Addendum #5 forRequest for Proposal For Campus Health Clinic Relocation: Project 122-293203 Dated January 2, 2018

Addendum Number: #5

Project: WSU Campus Health Center

CAMPUS HEALTH CENTER
1st Floor
Build Out

Sheet #A4-01, Finish Schedule and Details

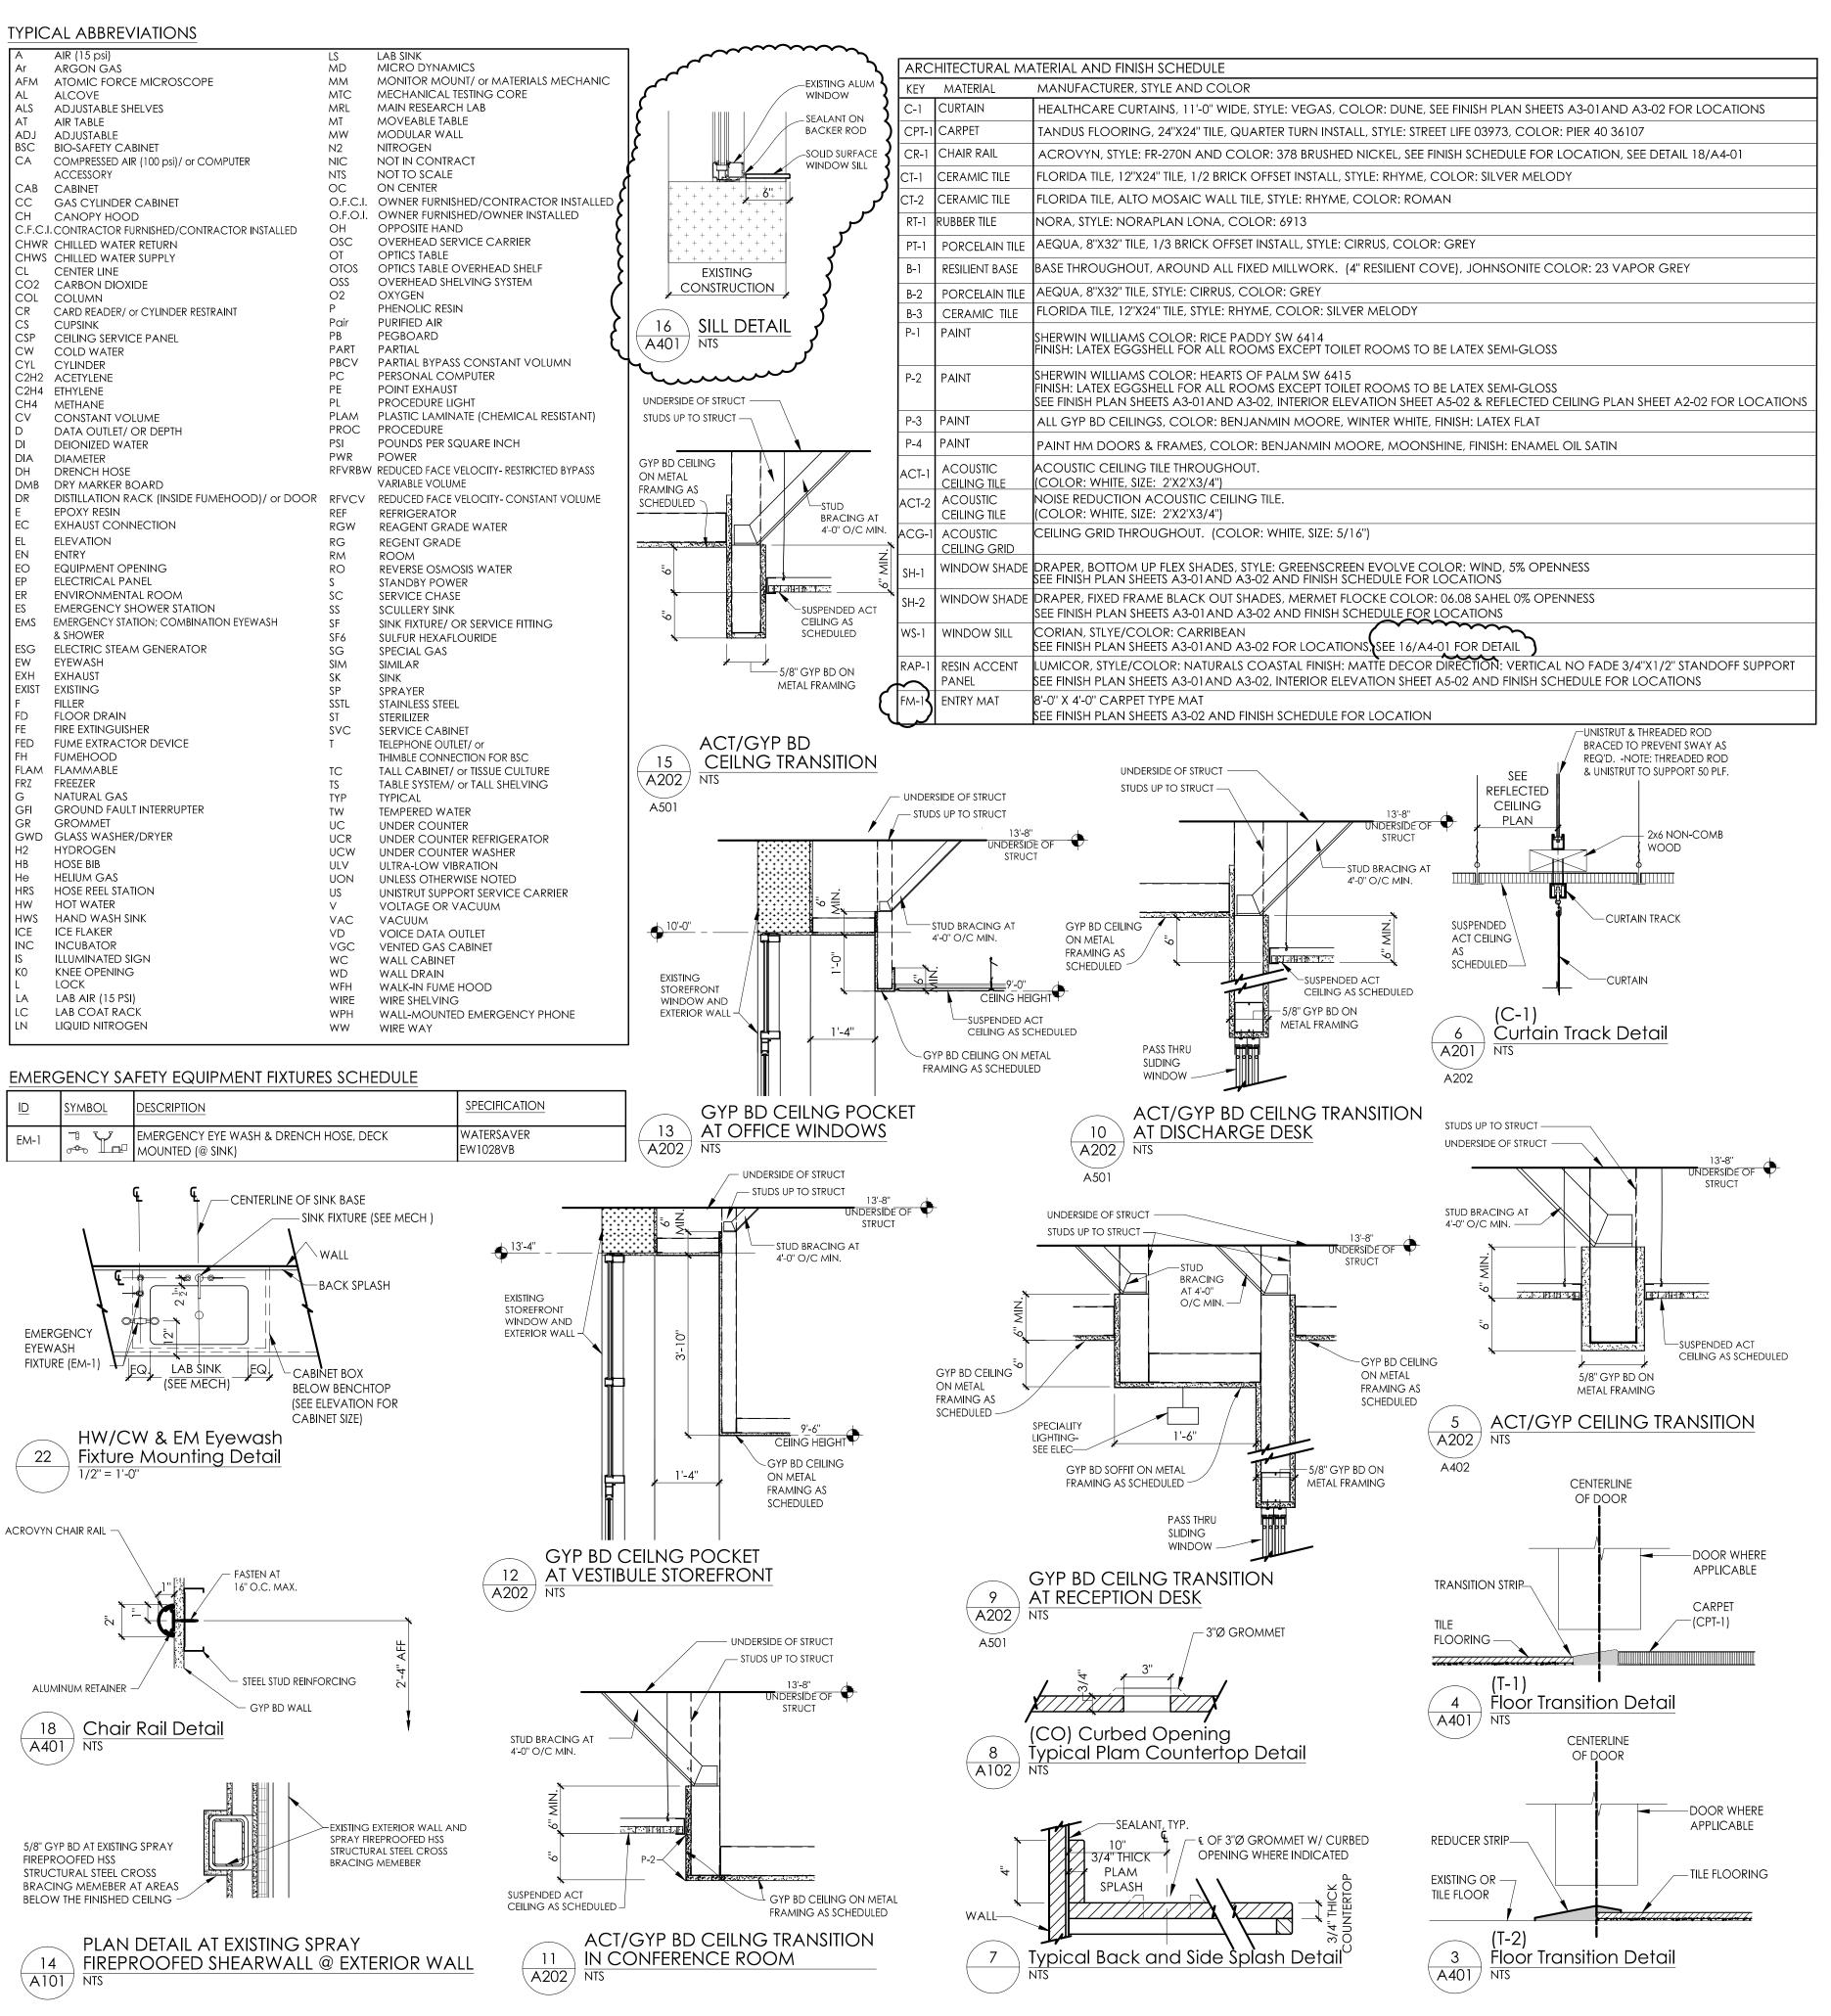
2. Can you provide a Section cut of Exterior window sill of Corian Caribbean at exterior windows For the resin wall panels, what is the thickness of Lumicor mounted to walls 1/4" or 3/8"?

Description: Added detail 16/A4-01 at exterior window sill.

Answer: 1/4" AS LISTED ON IN SPECIFICATION SECTION 10 20 00-4. SECTION CUT WILL BE PROVIDED WITH ADDENDUM #5 ISSUE.
